**Project Details:**  
 Dalgise  
 Monkstown

**Drawing Title:**  
 Proposed Elevations + Section - Block E

Status	Purpose of Issue	Revision
P01	PLANNING PERMISSION	
MKS-RAU-E-ZZ-DR-AR-200		P02

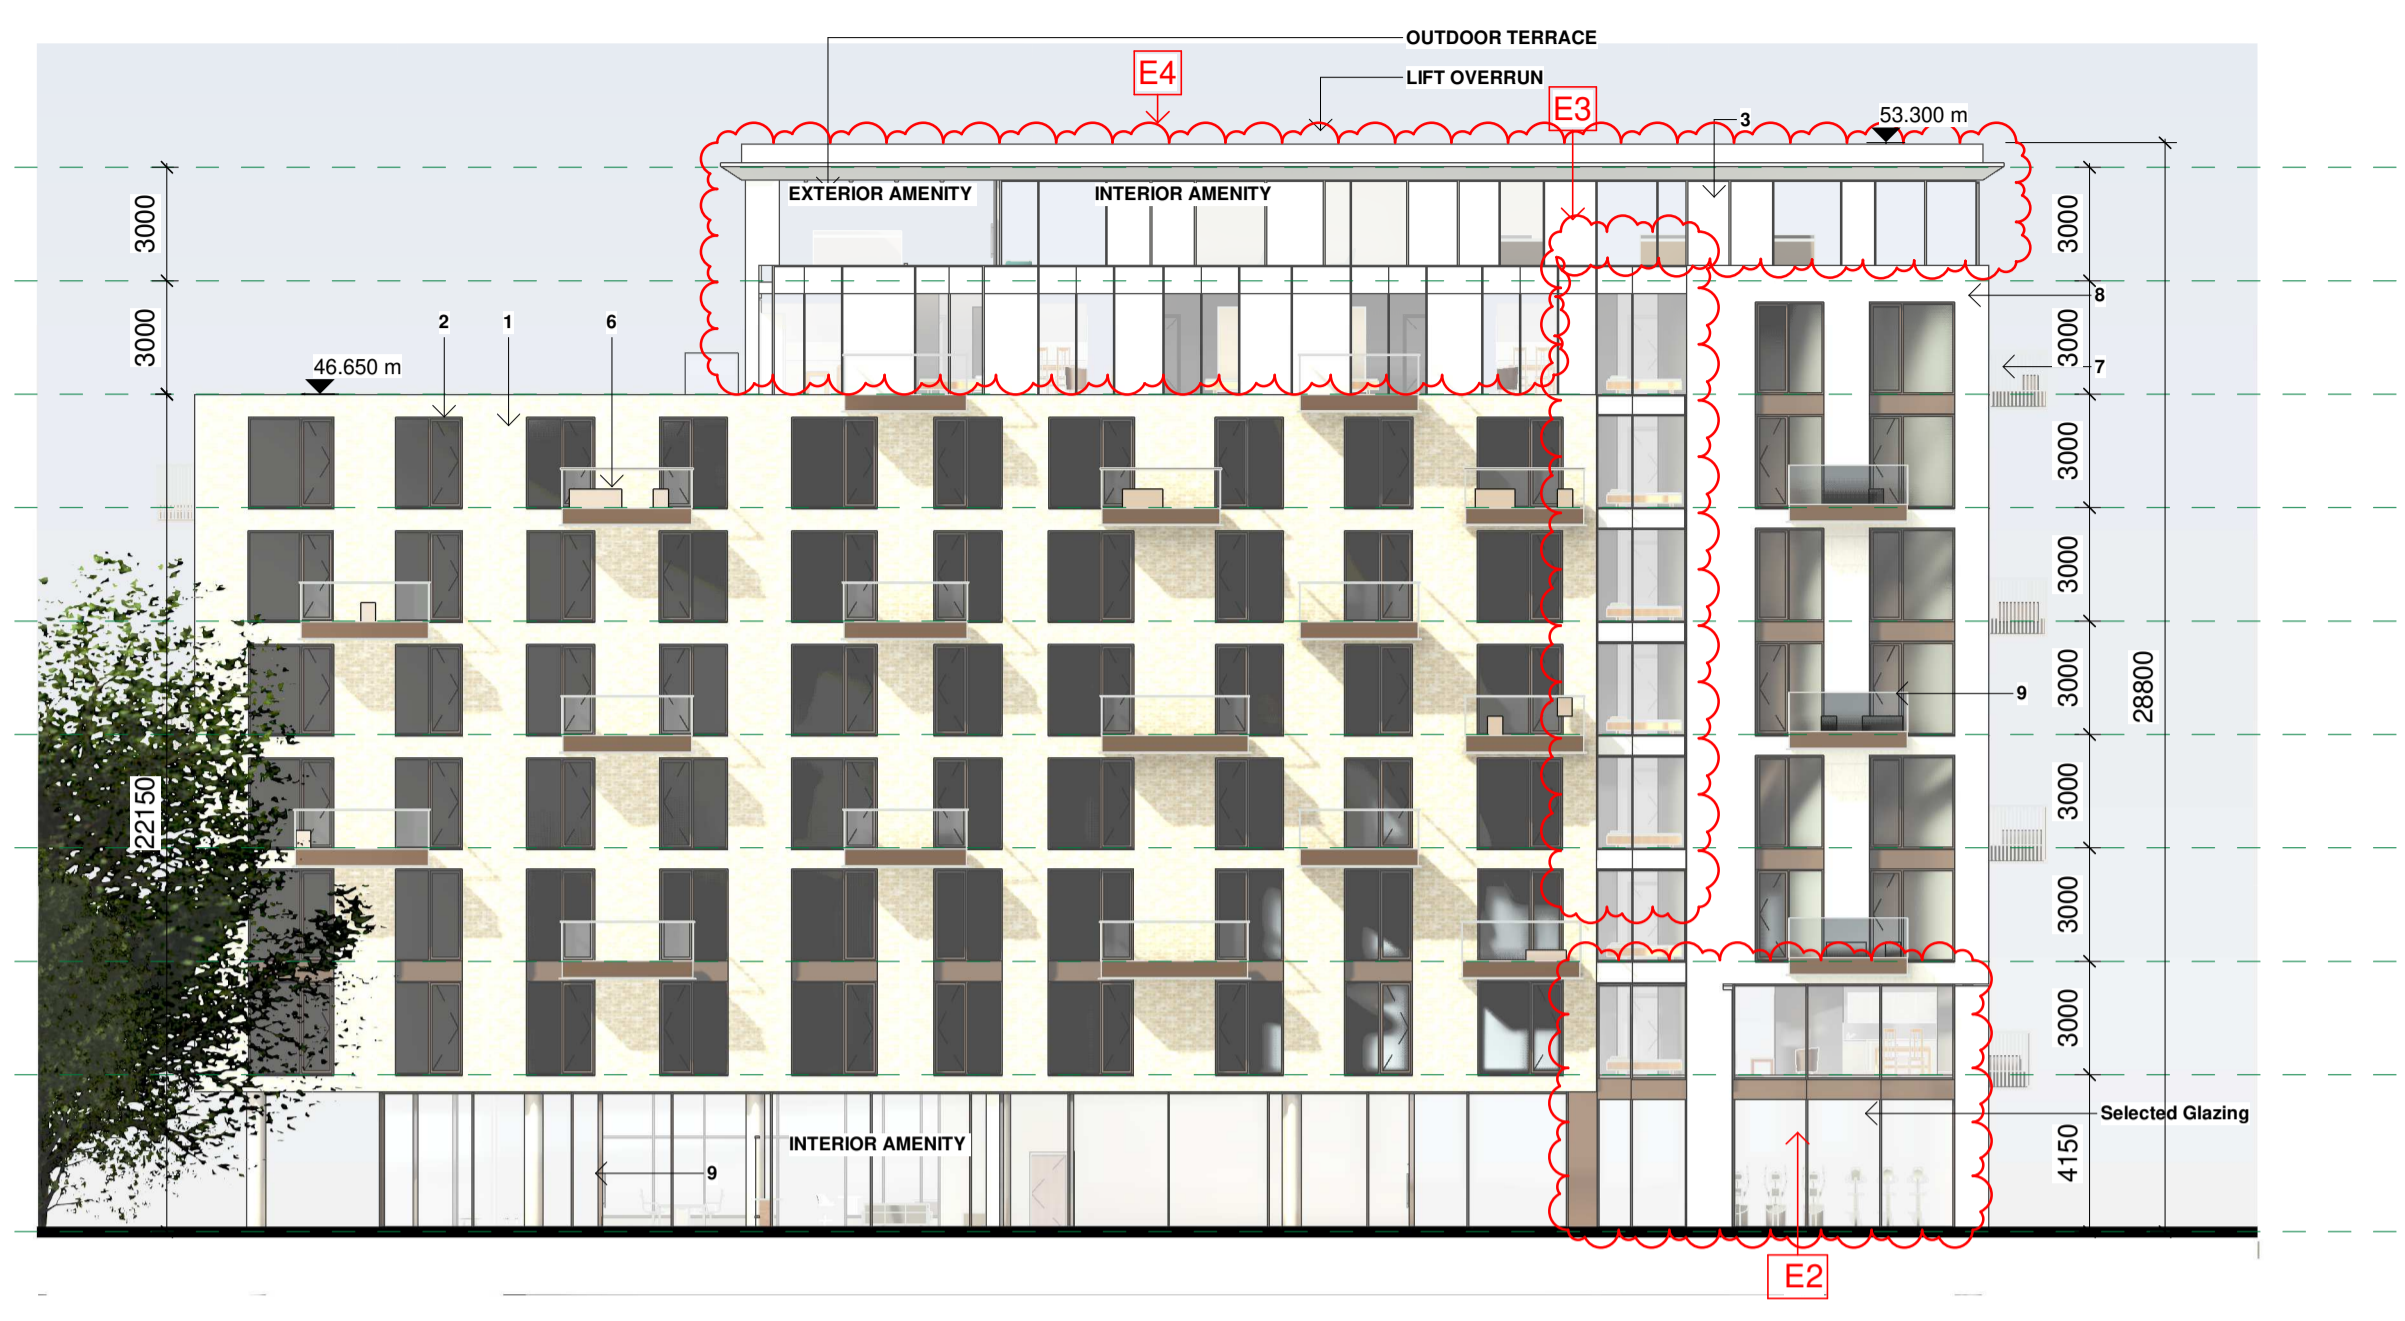
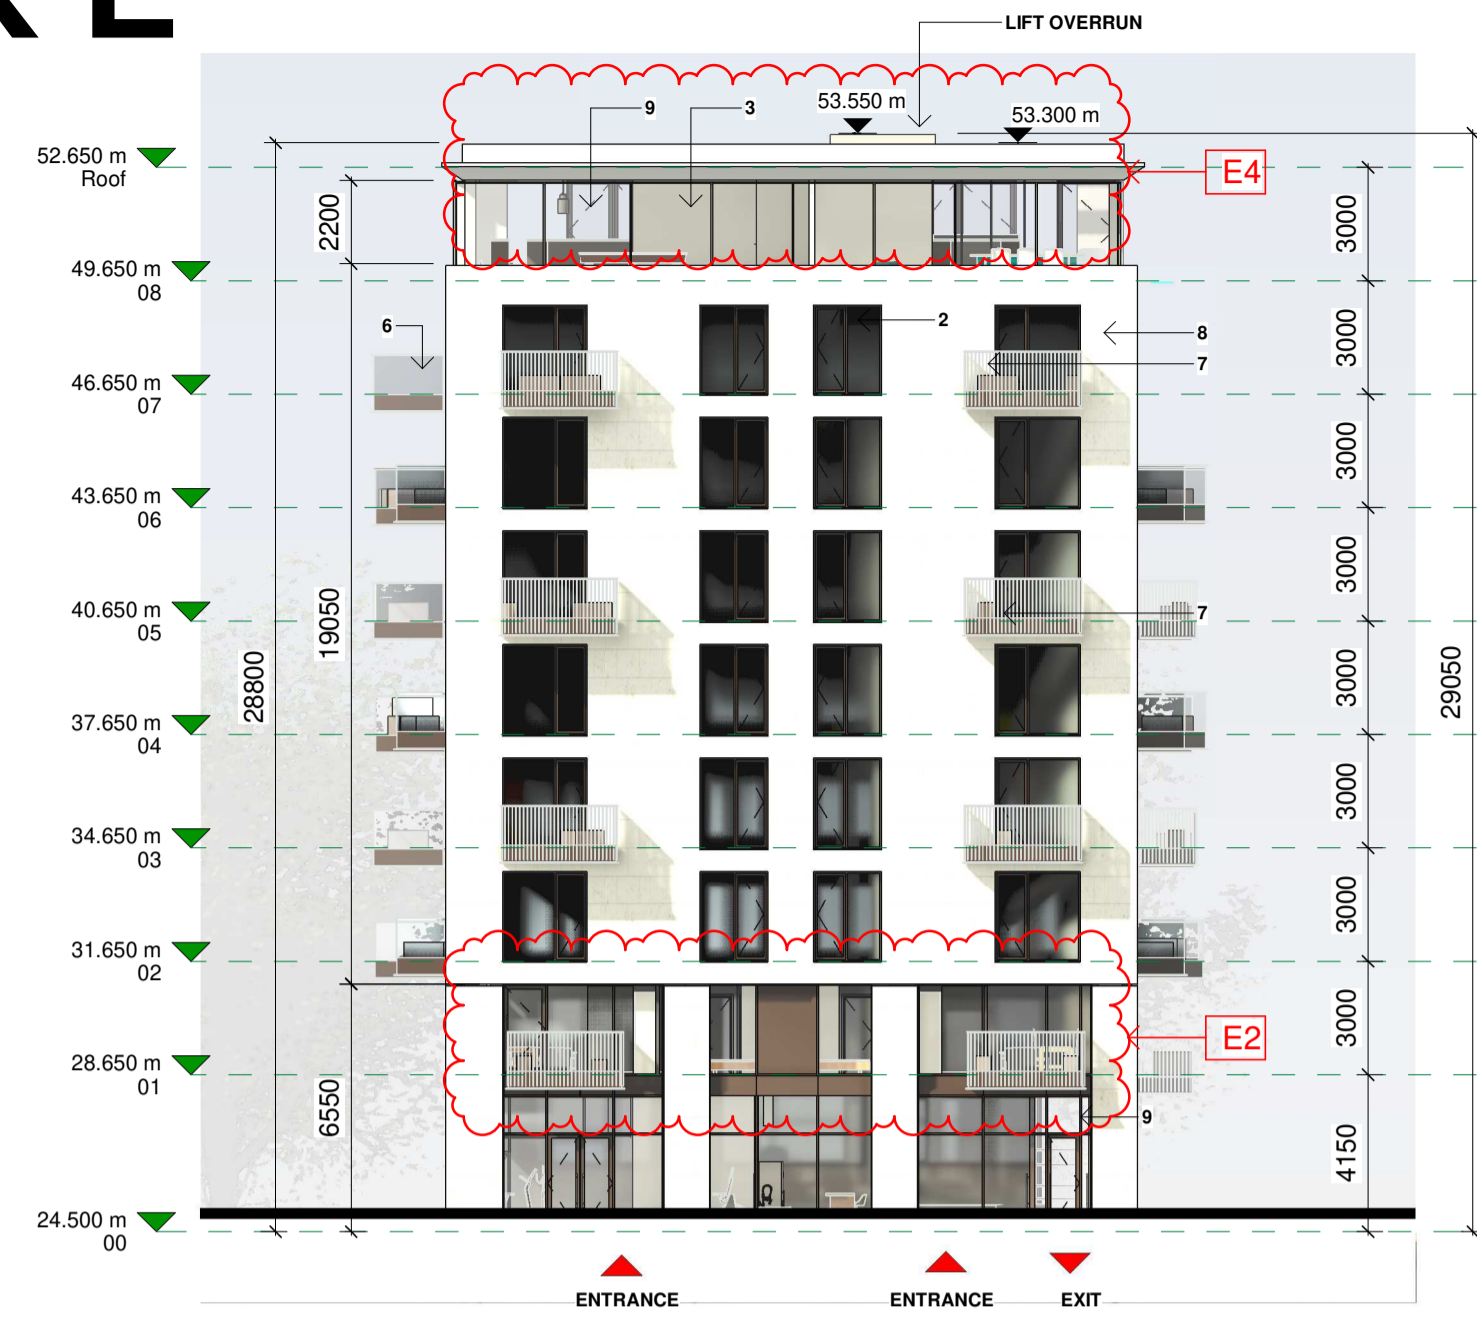
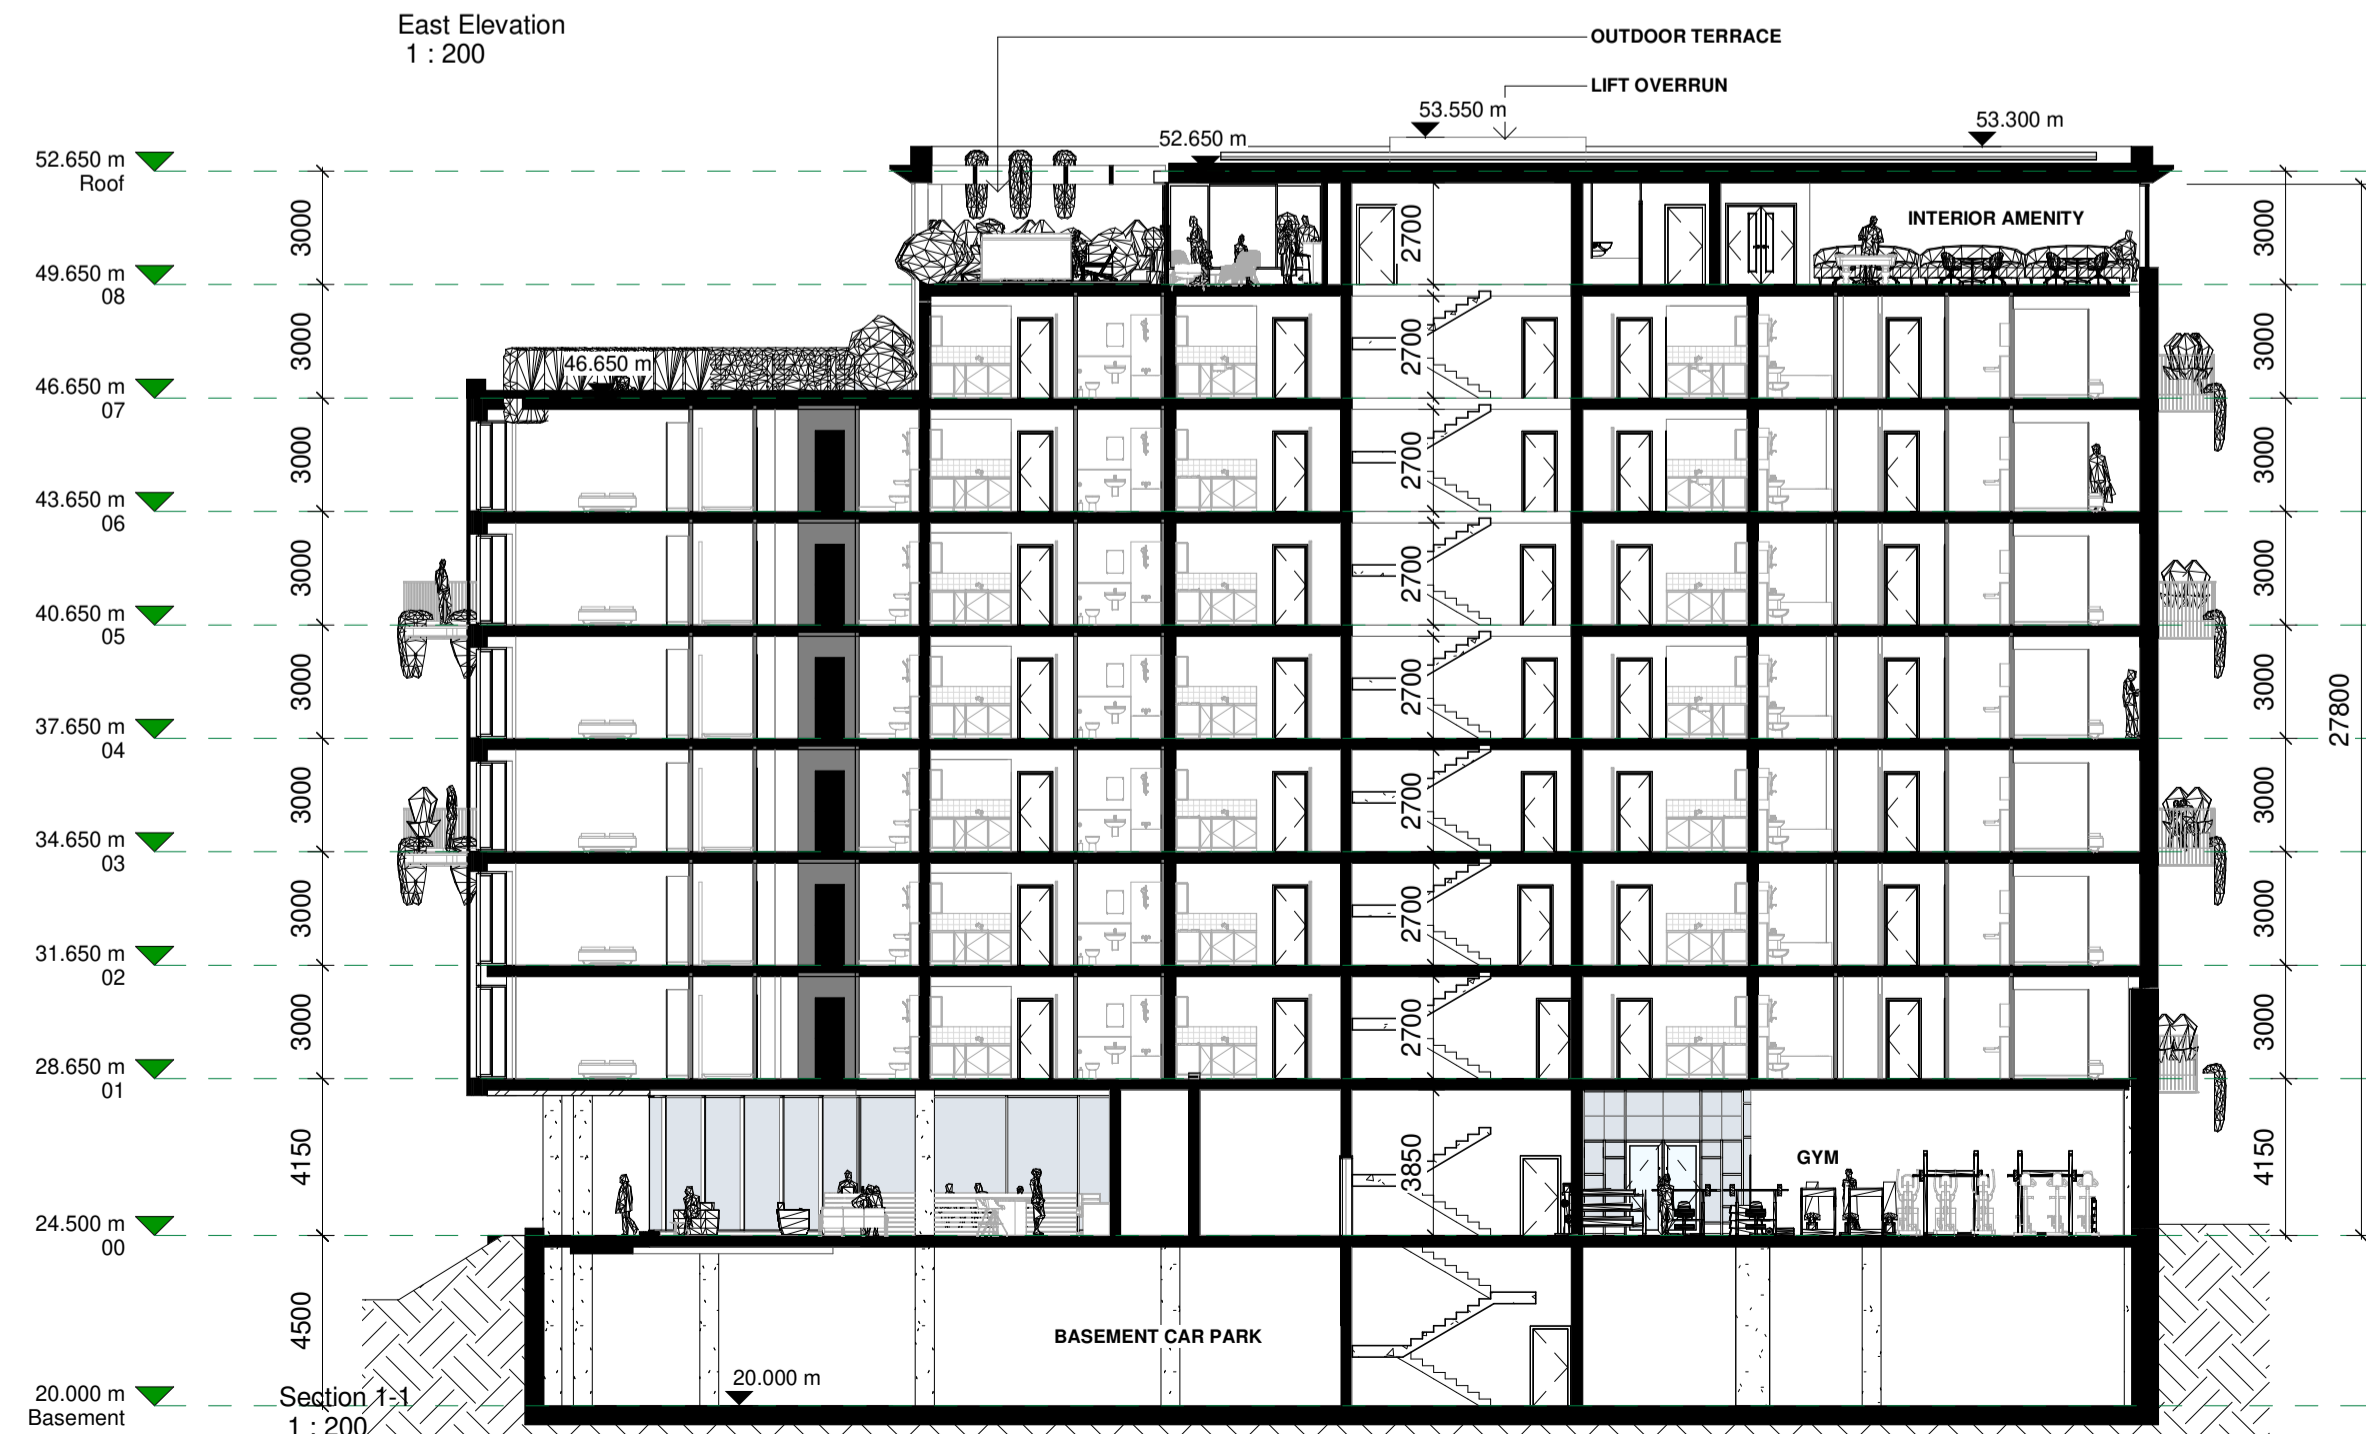
- REVISIONS**
- E1. Double Height Entrance Foyer, Mezzanine Floor with bookable rooms added.
  - E2. Glazing brought up extra level to first floor.
  - E3. Glass Shadow gap location and size revised.
  - E4. Tonal change at Penthouse Level and spandrel panels / balconies
  - E5. Steps to north of Block E omitted.
  - E6. Balcony positions altered from previous submission.
  - E7. Secure Bicycle Storage added and car parking re-configured.
